Attachment 1 – Roadway System Refinement Details

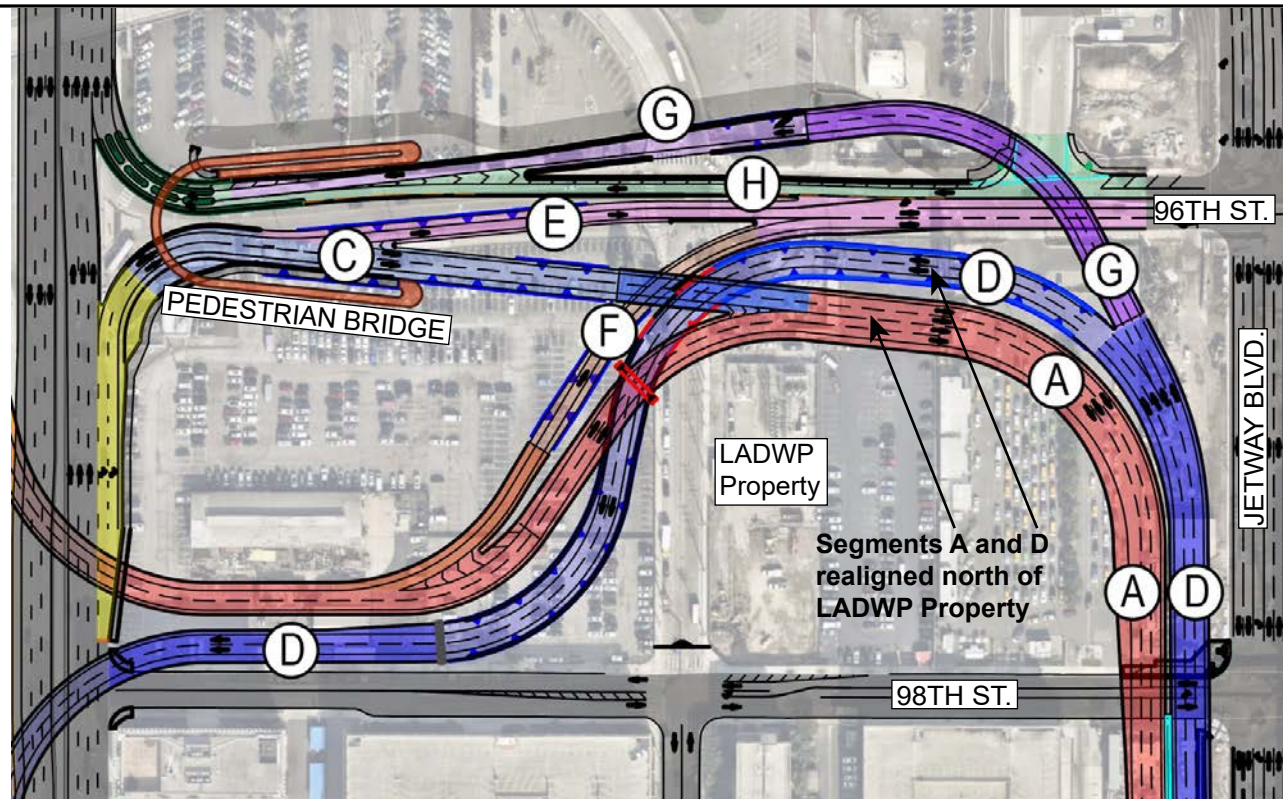
Image 1: Between Jetway Boulevard and Sepulveda Boulevard, roadway Segments A and D would be realigned to avoid the LADWP property; the realignment would also reduce operational impacts on the Sunrise Parking property.

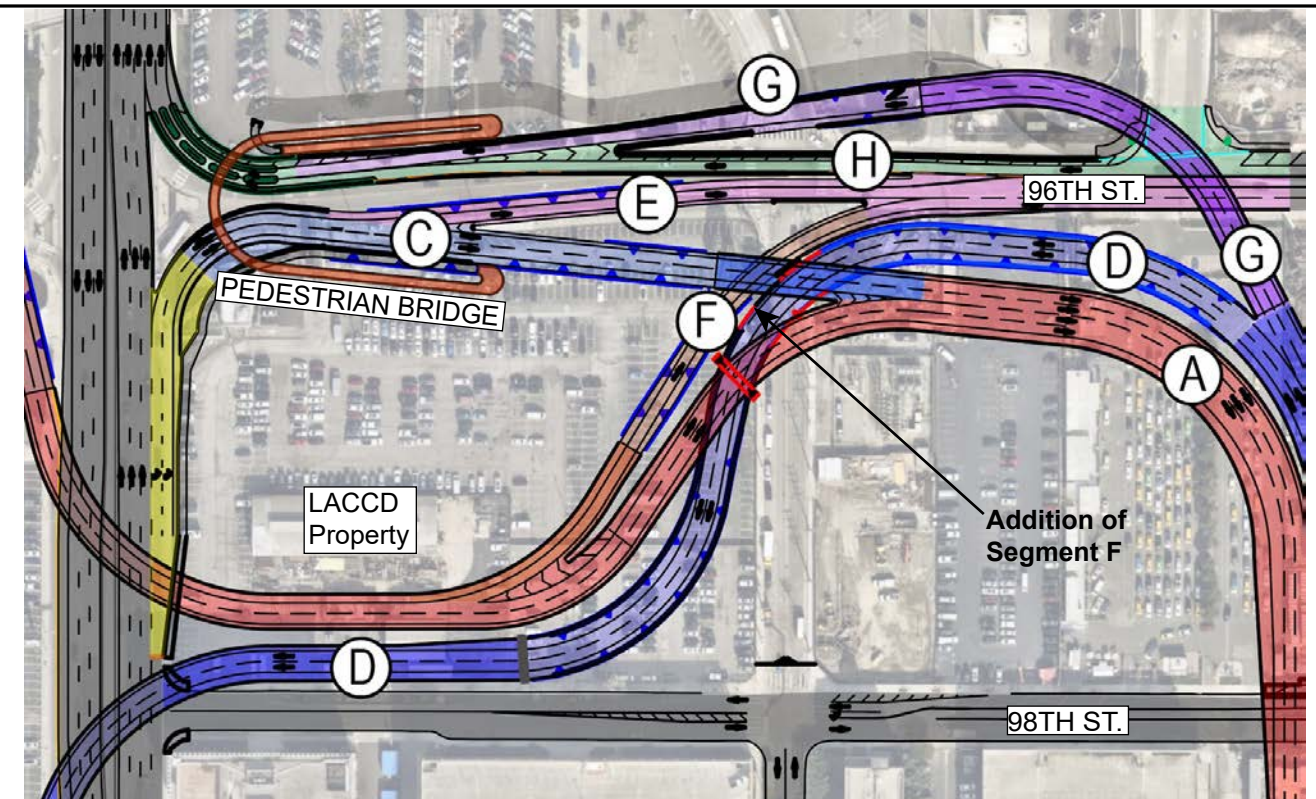
Image 2: Segments A and D realignments and addition of Segment F (Figure 1B, Image 6) would require additional property acquisition at the LACCD property.

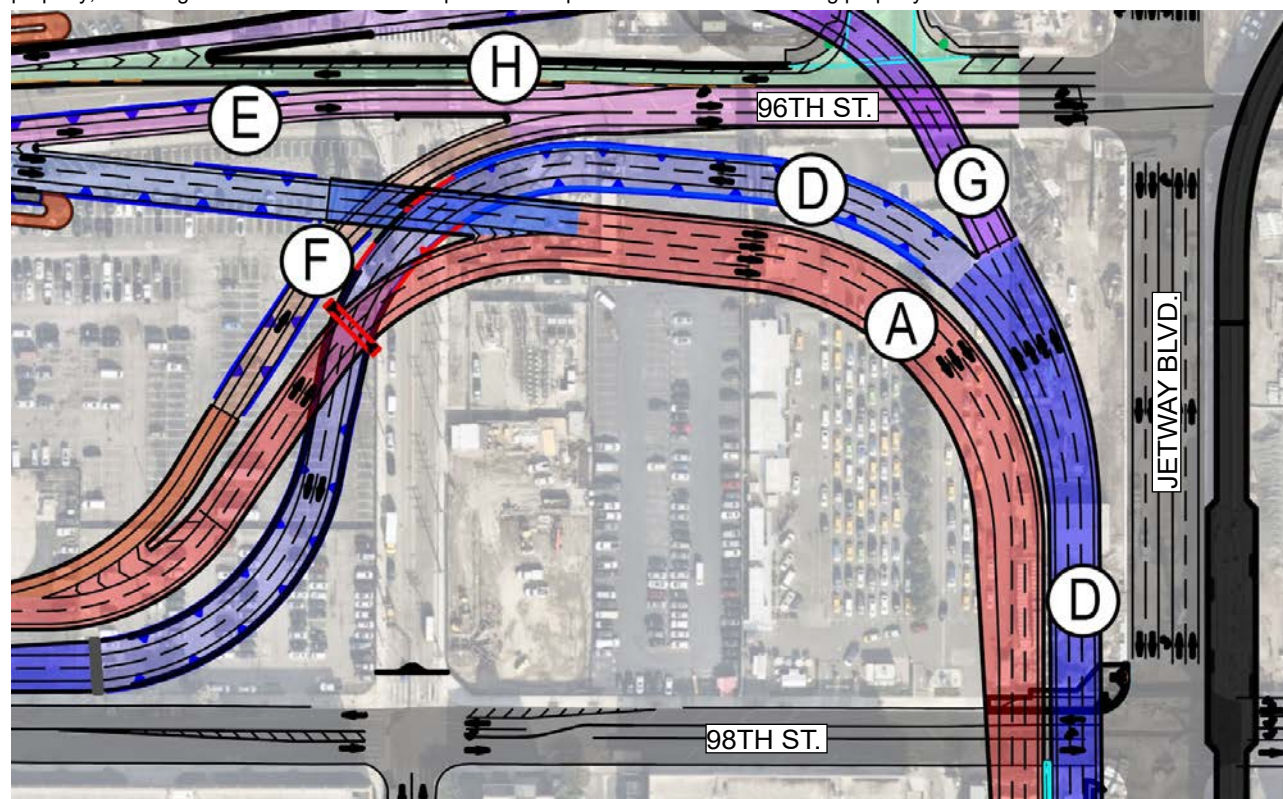
Image 3: The connection from Segment G to 96th Street eastbound (via Segment F) under the Approved Roadway System, which would have also provided access to Jetway Boulevard, would be eliminated. Under the Proposed Roadway System Refinements, outbound access from the Central Terminal Area to Jetway Boulevard would be provided by Century Boulevard via Segments P and R, shown in Image 10.

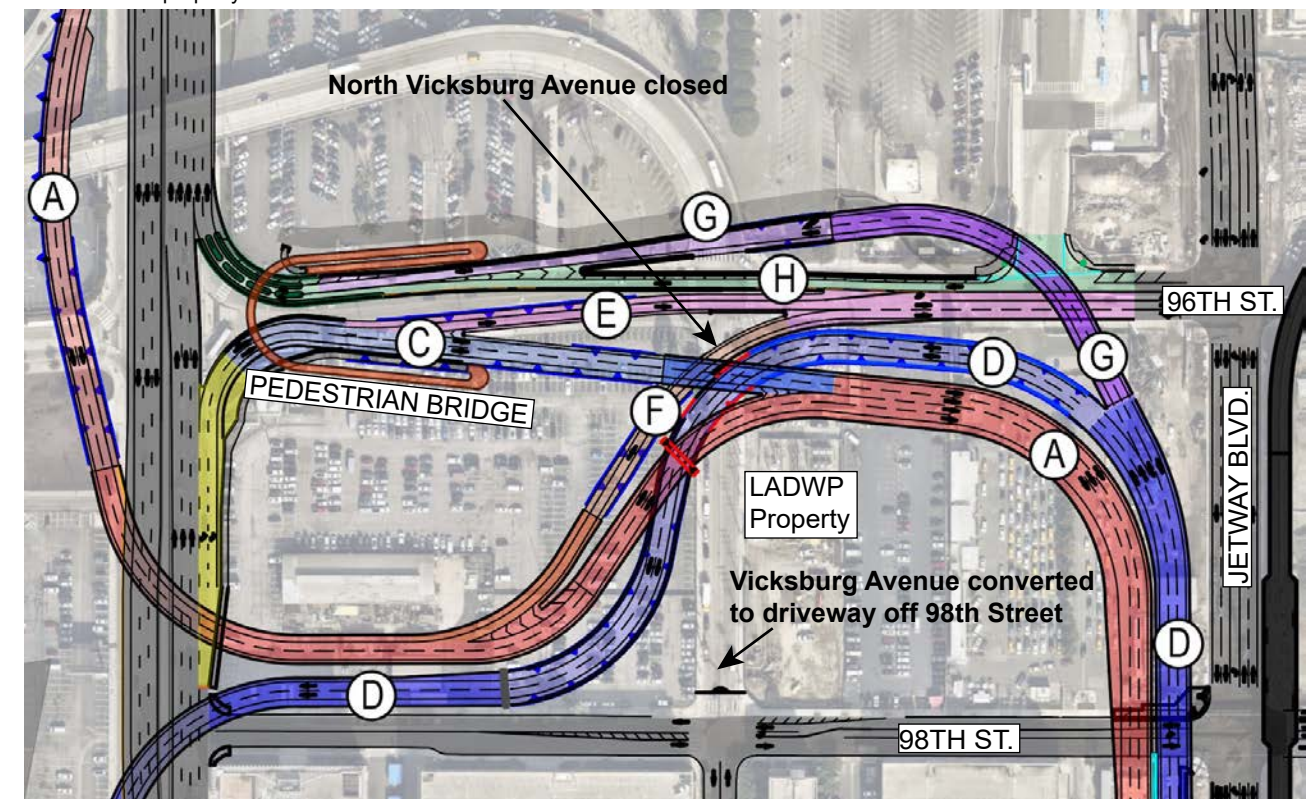
Image 4: Through access on Vicksburg Avenue between 96th Street and 98th Street would be eliminated; the connection between Vicksburg Avenue and 96th Street would be removed and the remaining southern section of Vicksburg Avenue would be converted to a driveway for LADWP property. The driveway entrance would be from 98th Street.

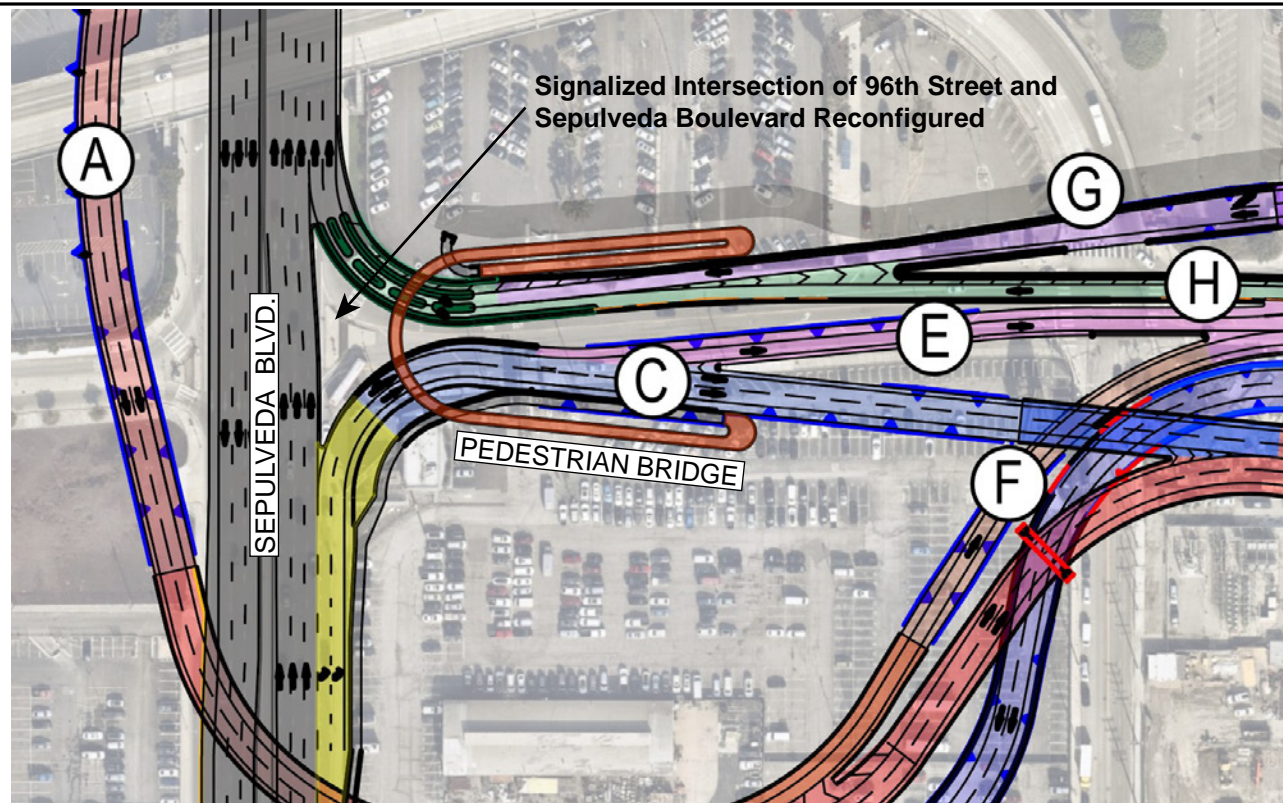
Image 5: Intersection of 96th Street and Sepulveda Boulevard would be reconfigured to eliminate the need for future signalization of the intersection, which would result in improved operations on Sepulveda Boulevard compared to a signalized intersection (i.e., reconfiguration would eliminate the need for a signal to enable SB traffic on Sepulveda Boulevard to turn left for EB travel on 96th Street); reconfiguration would include additional turning lanes on Sepulveda Boulevard.

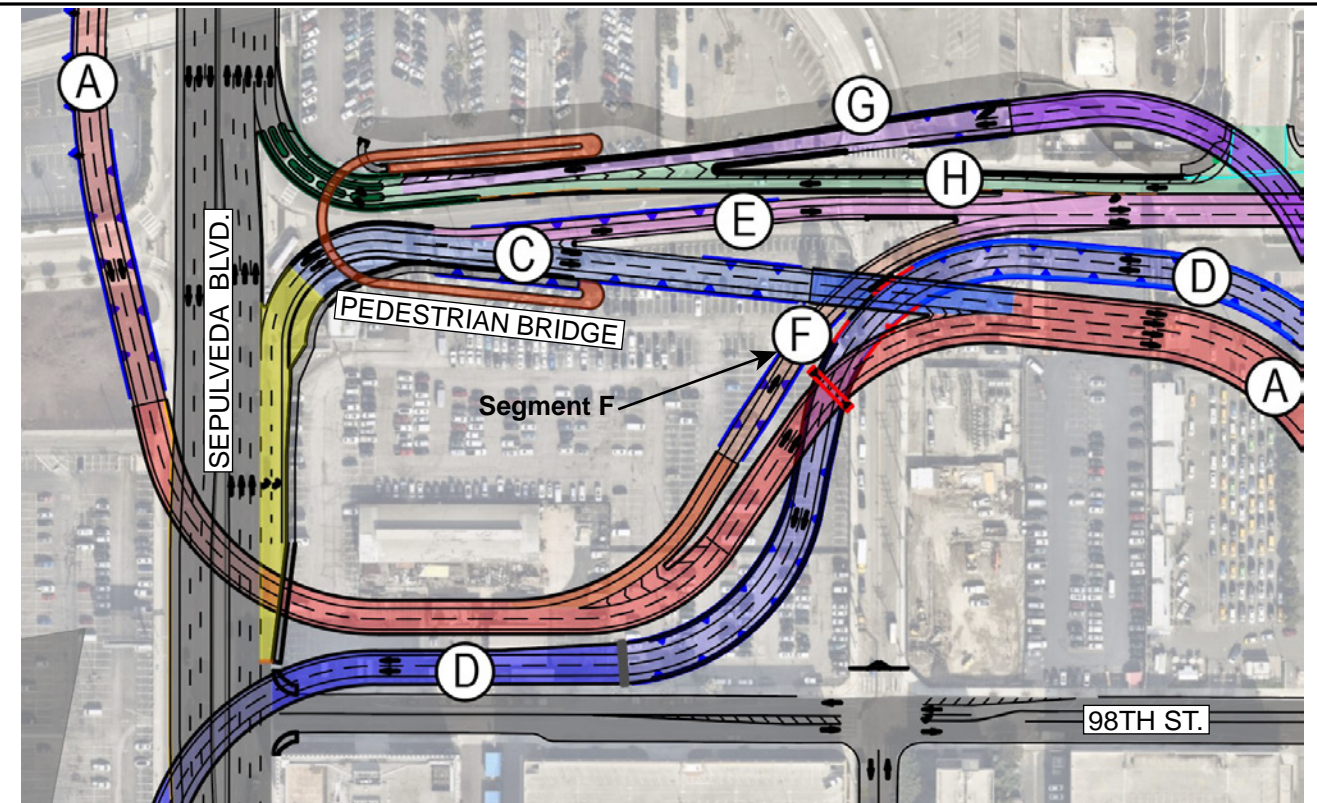
Image 6: The eastern portion of Segment F would be relocated/reconfigured to be an offramp from Segment A and connect to EB 96th Street. With Segment A being elevated above Sepulveda Boulevard, this would enable movement from Sepulveda Boulevard southbound to 96th Street eastbound to occur without the need to install a traffic signal at Sepulveda Boulevard and 96th Street.

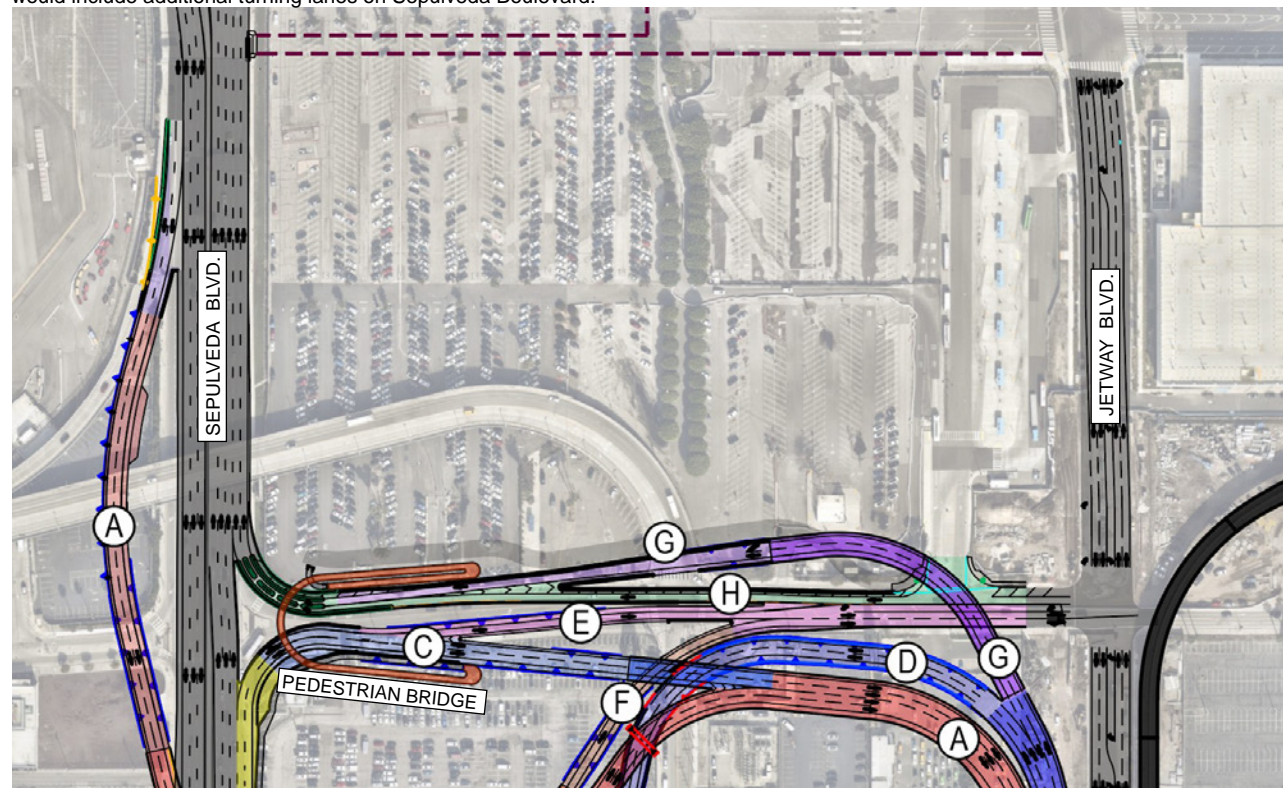
Image 7: A pedestrian bridge would be added over 96th Street east of Sepulveda Boulevard.

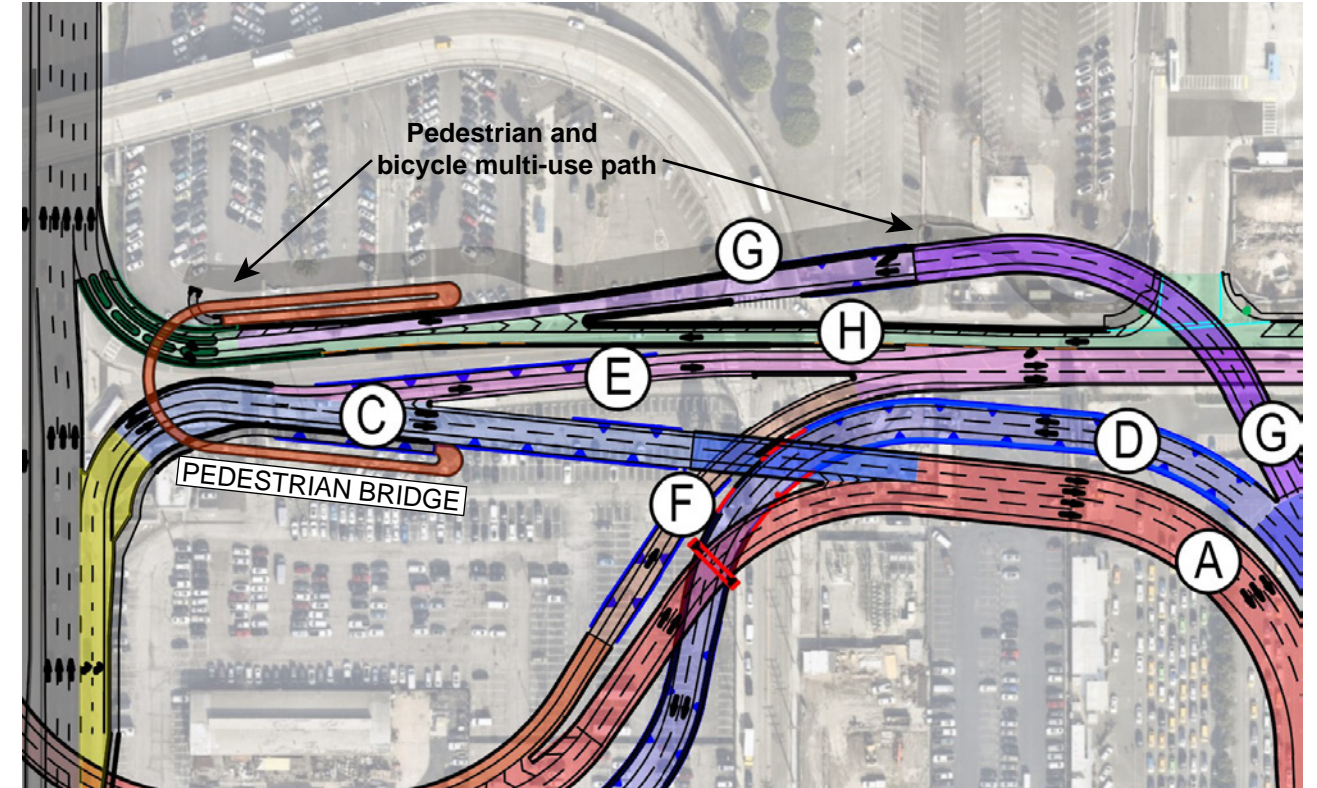
Image 8: A pedestrian and bicycle multi-use path would be added along 96th Street westbound from Jetway Boulevard to Sepulveda Boulevard.

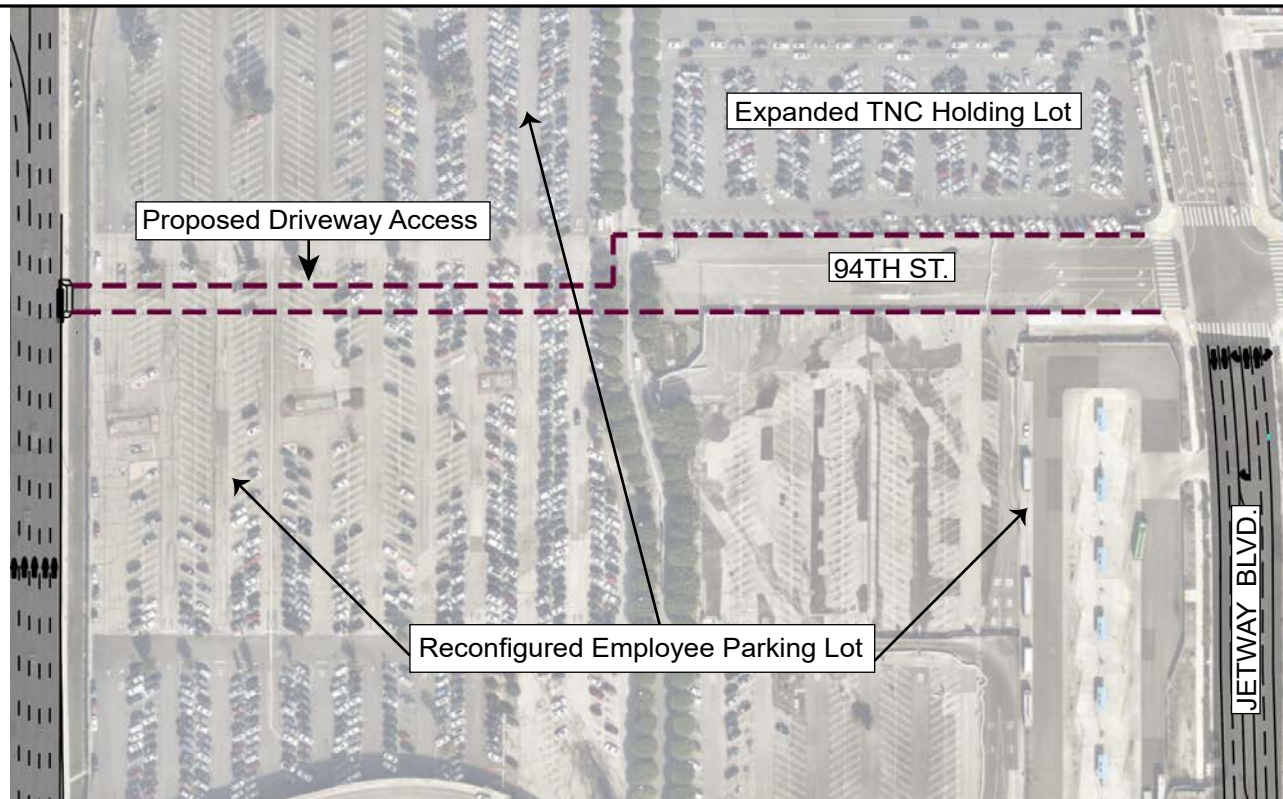
Image 9: A new driveway access would be provided from northbound Sepulveda Boulevard to the east in line with 94th Street. The existing parking lot/vehicle staging areas would be reconfigured as follows: the areas south of 94th Street and in the northwestern quadrant would be used for employee parking; the northeastern quadrant would house the expanded TNC Holding Lot and, to the north of that, the relocated LAX Taxi Staging Lot (not shown). The existing airport shuttle/limousine staging area would be relocated to the northeast corner of Airport Boulevard and 96th Street (not shown).

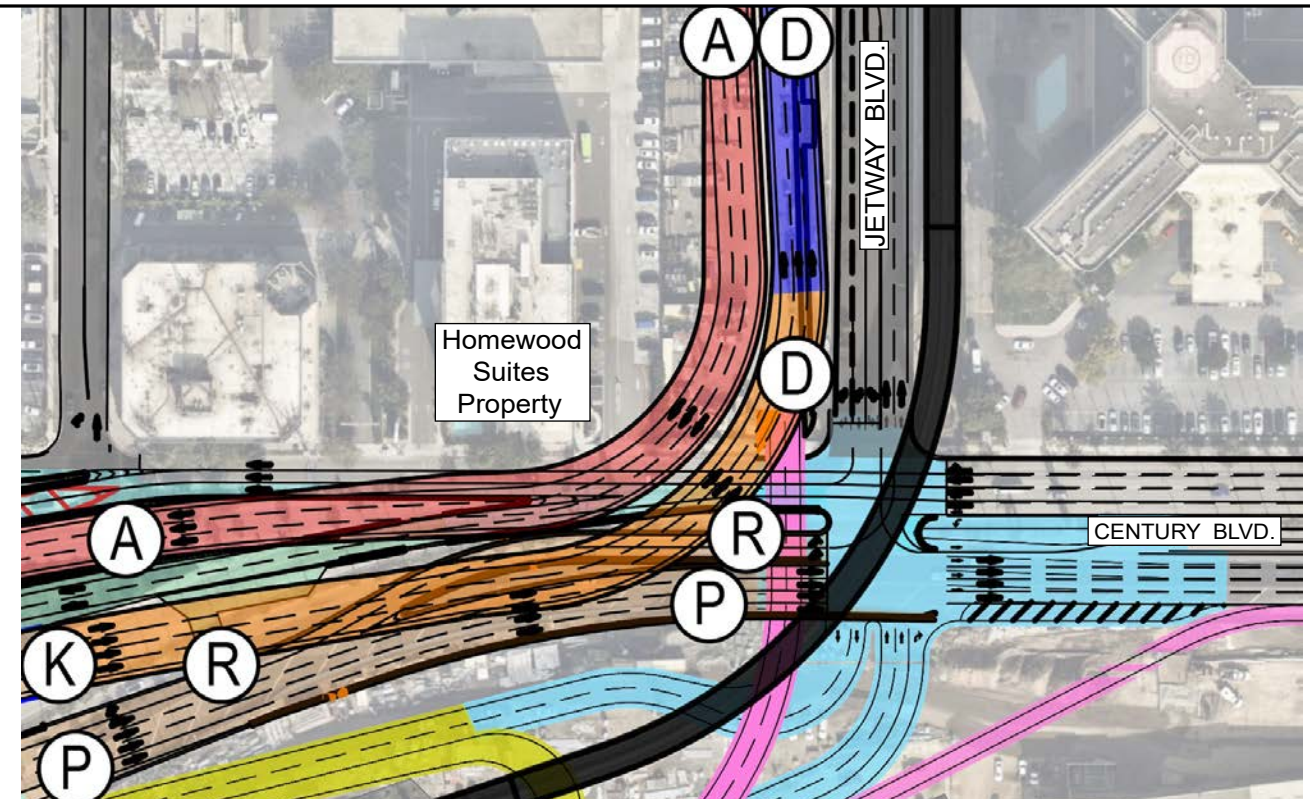
Image 10: An aerial easement would be required at the Homewood Suites property to enable the elevated roadway structure.
